PRELIMINARY PLAN

PCD NO. SP-23-009

| PRAIRIERIDGE FILING NO. 1 PRELIMINARY PLAN | | | | | | | | |

TRACT TABLE

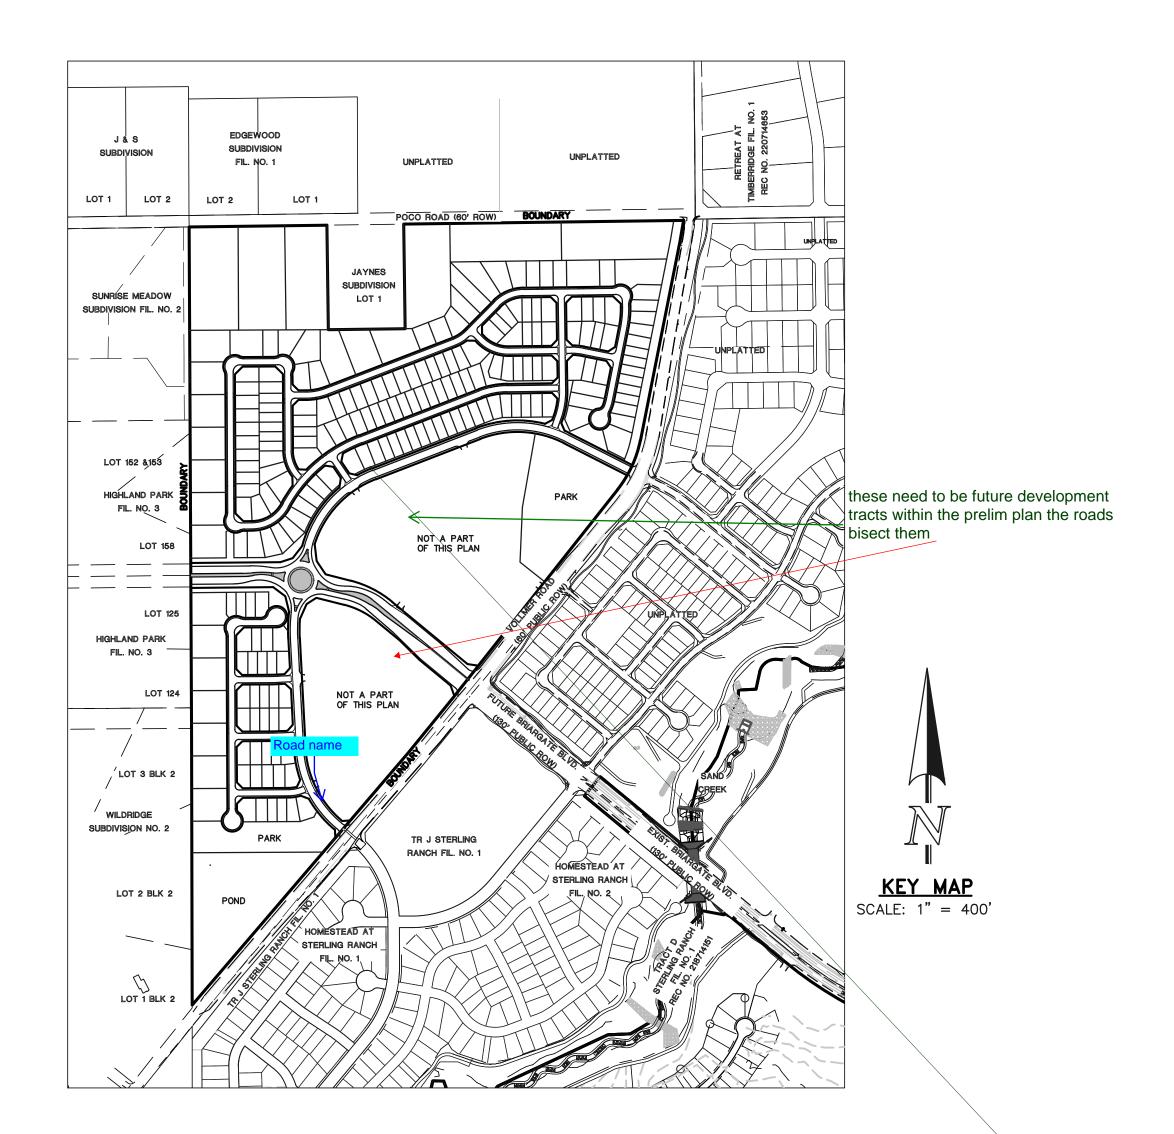
ct B on plan sheet. Please update

clude Geohazard Note

Please review title work exceptions identify easements/ water rights that will remain and be vacated or subordinate

> depict trees to be preserved w/ nets as no build /no disturbance please

add a note to address this in lieu of mapping unless you want to map

draw phase lines please. Add a note phase lines may change at final p;lat stage; no amendment

EGAL BOUNDARY EXHIBIT AND

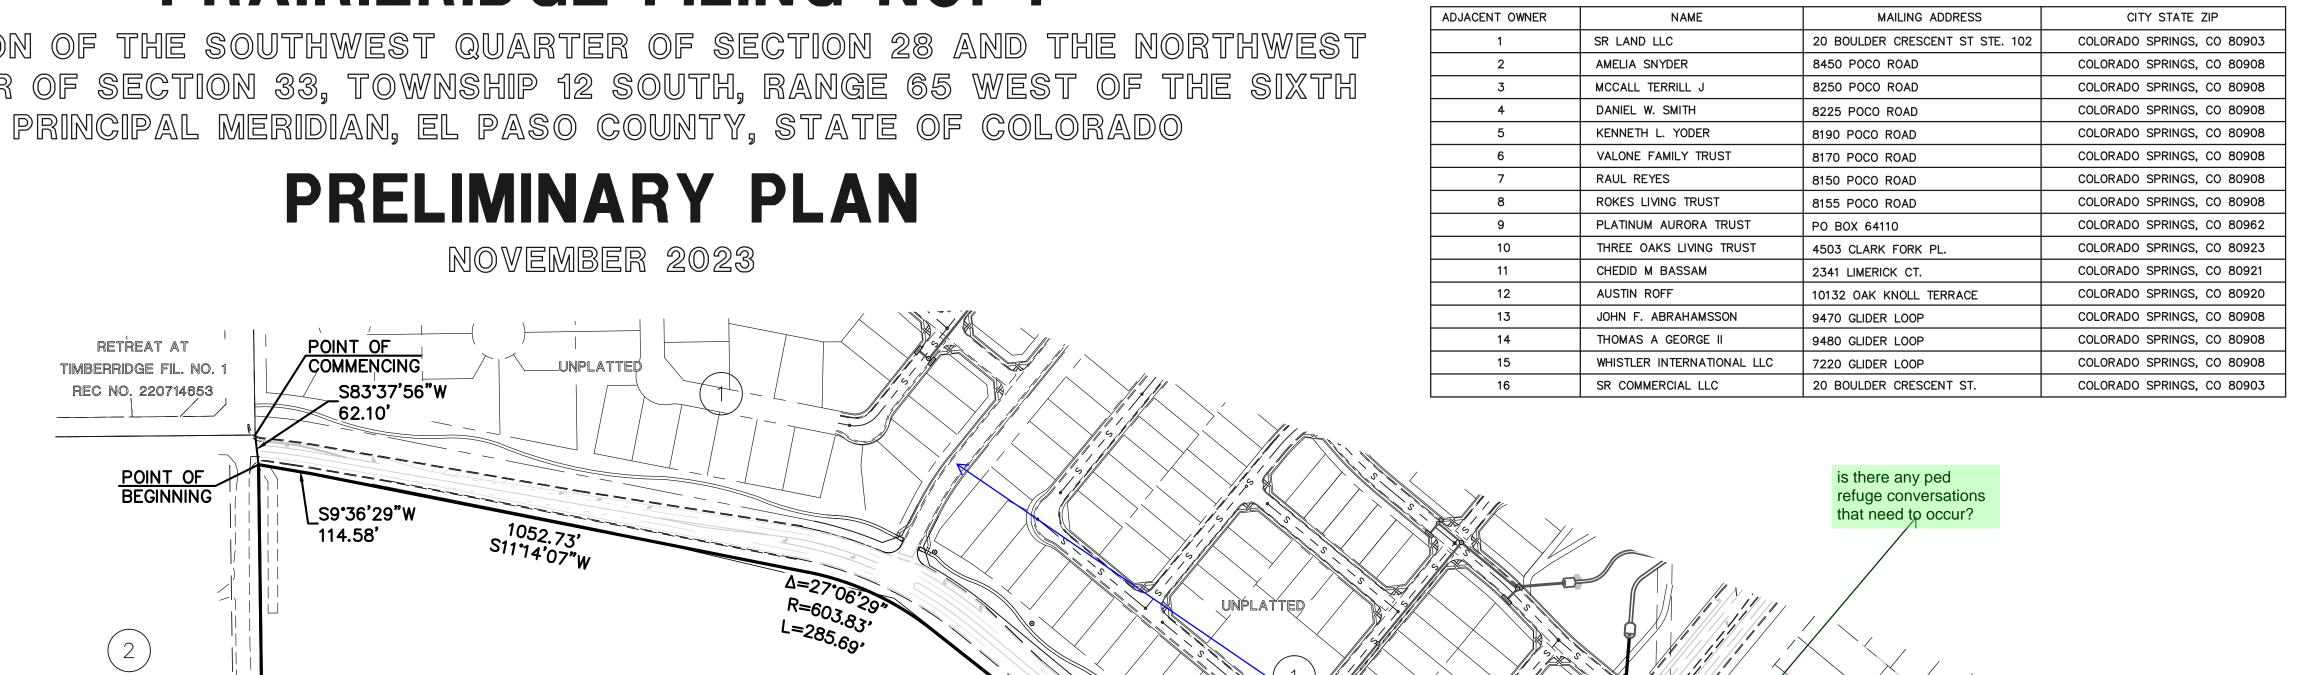
387.95' N9*57'35"E N2'32'52"E Δ=31°02'16" R=535.00' these need to be future development tracts within the prelim plan L=289.82' S81°43'37"E 8250 POCO RD. NOT PART OF UNPLATTED RANCH FIL. NO. N0°46'54"W Δ=25*22'53" N19**°**48'18"W R=\$50.00' L=243.64' _N50**°**26**'**12"W 209.25 S75°49'05"E

544.44 _N75**'**49'05"W 151 10' 53'01'22"E 571.21' Please turn this so its same direction as other sheets EDGEWOOD SUBDIVISION FIL. NO. S56'42'05"W LOT 1 60.49 −Δ=7*35'39" R=770.00' L=102.06' 81.84

This does not match

the detailed sheets the

sheets dont inlude this

and likley

should as

NORTH PARK SITE

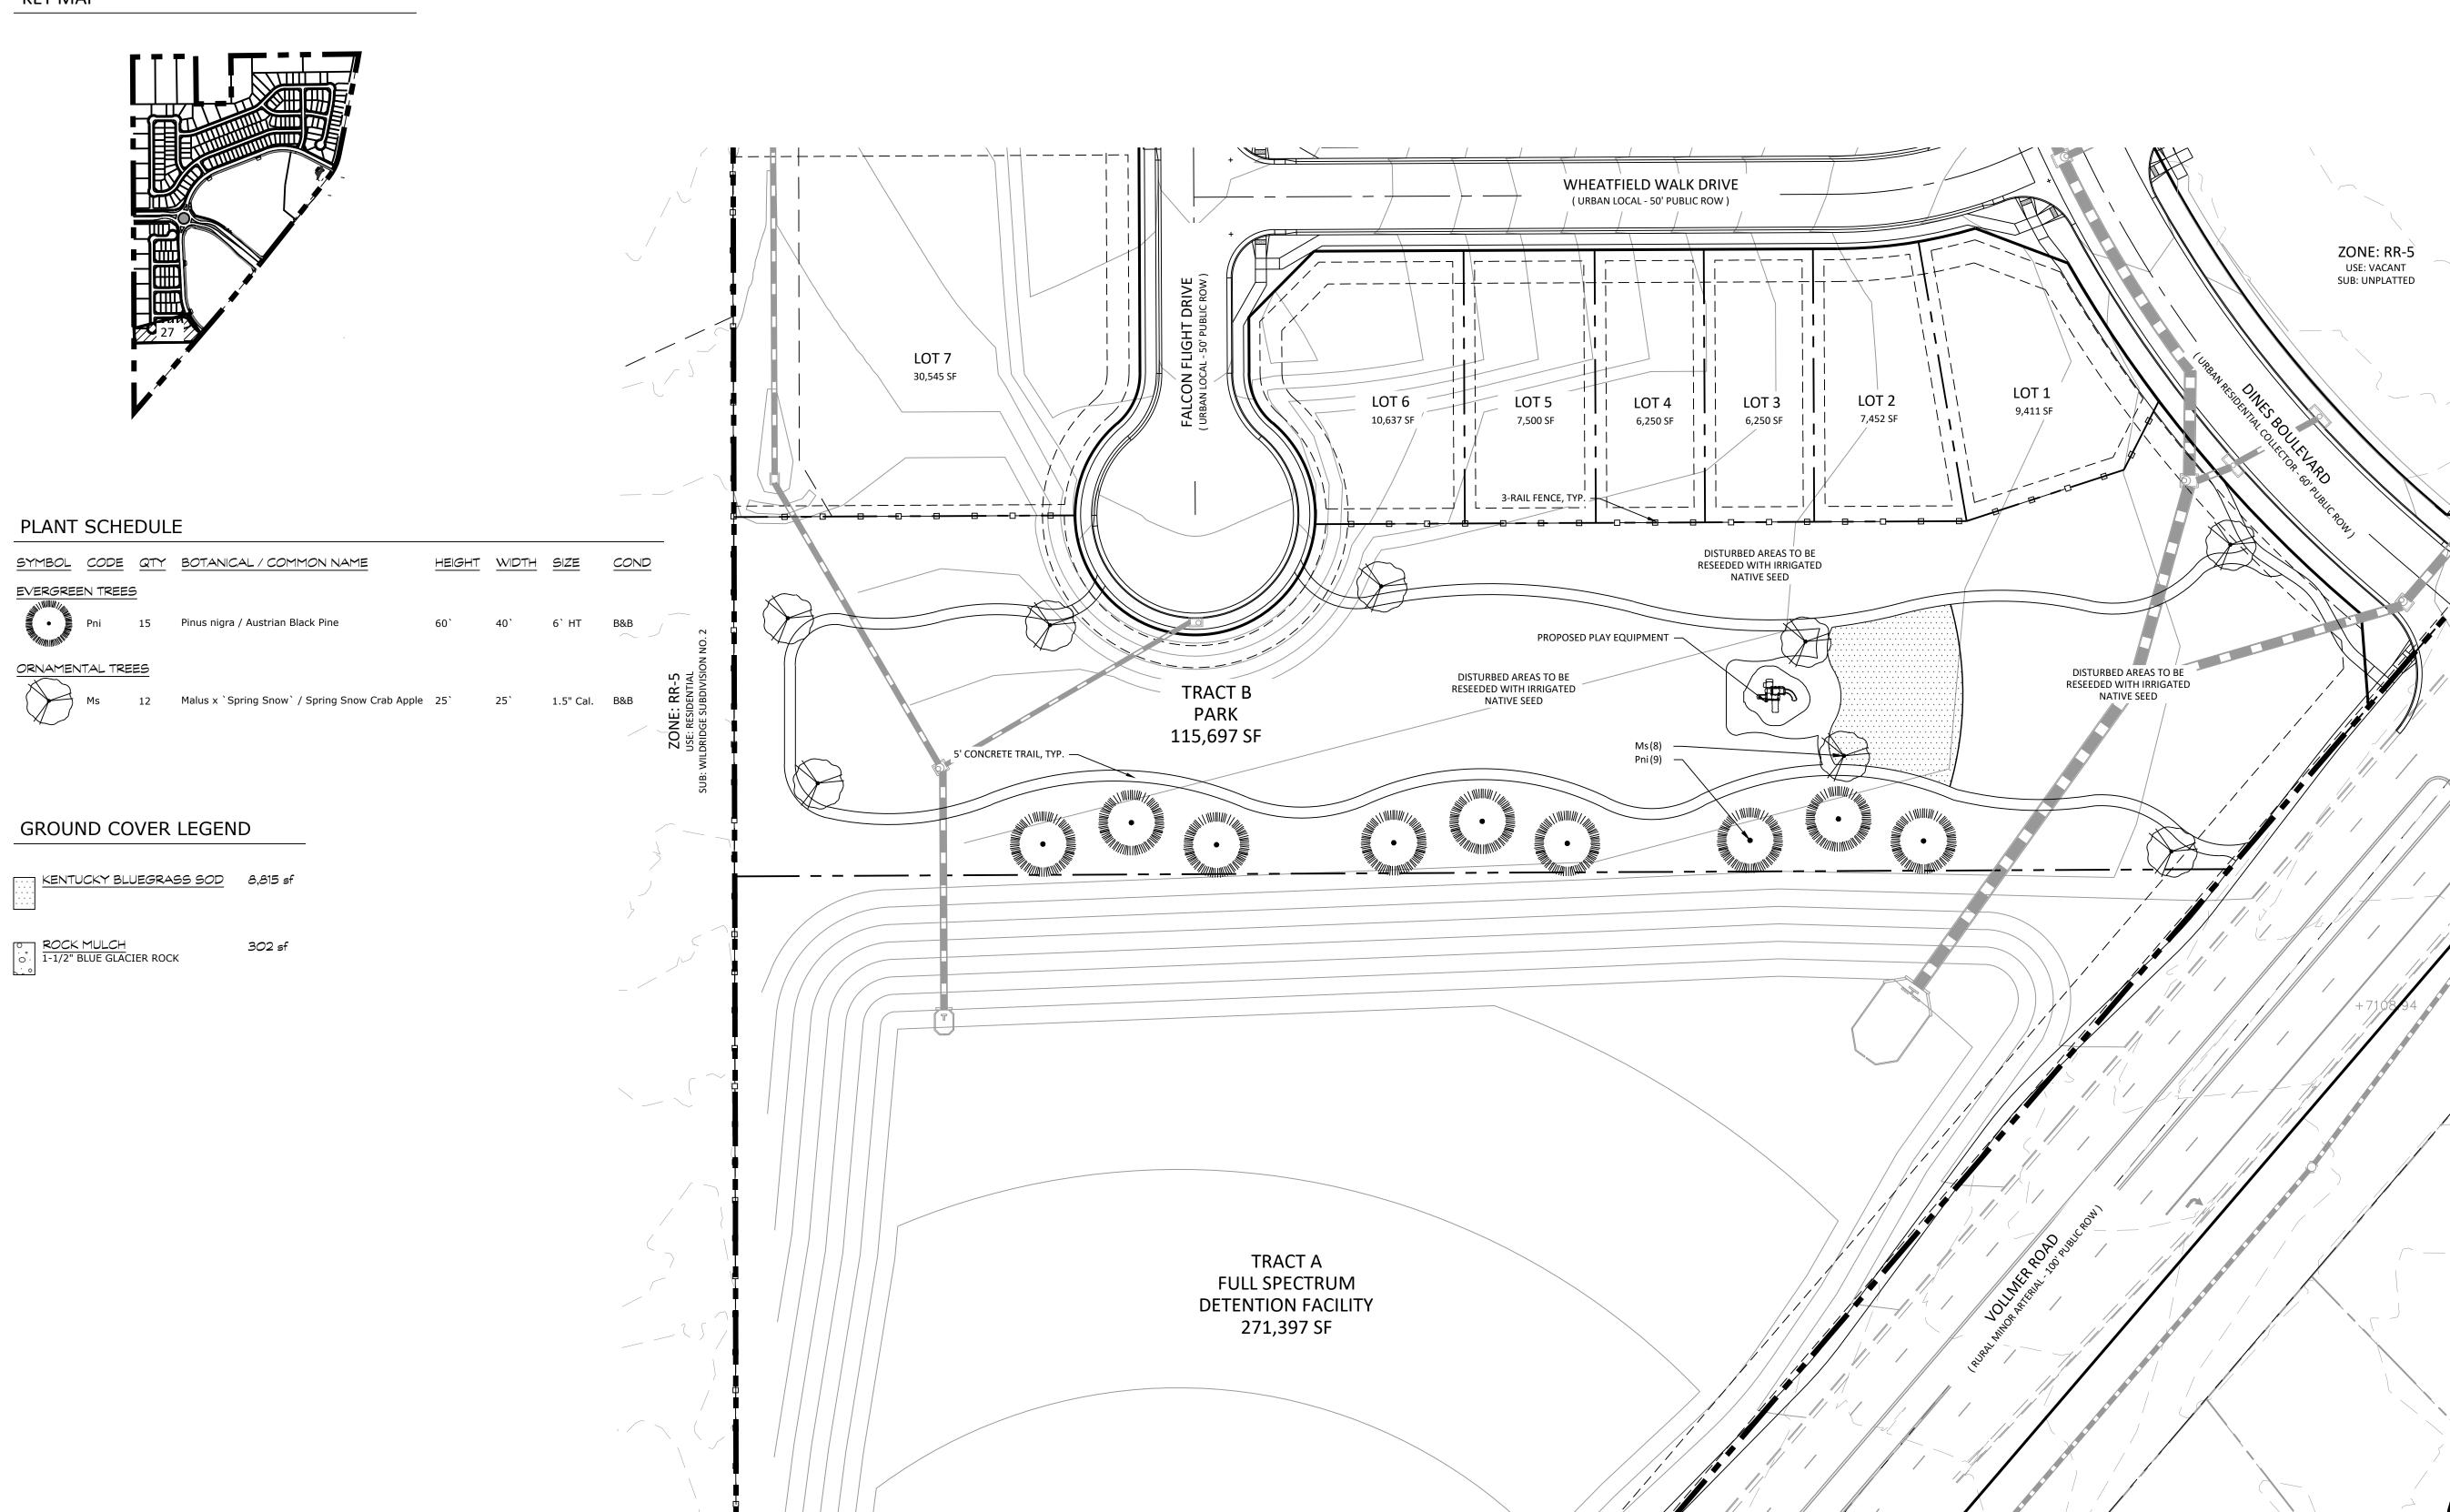
Preservation of pond and rapture nest trees was agreed at SKP hearing; please label trees that are to be protected and pond;

update letter of intent
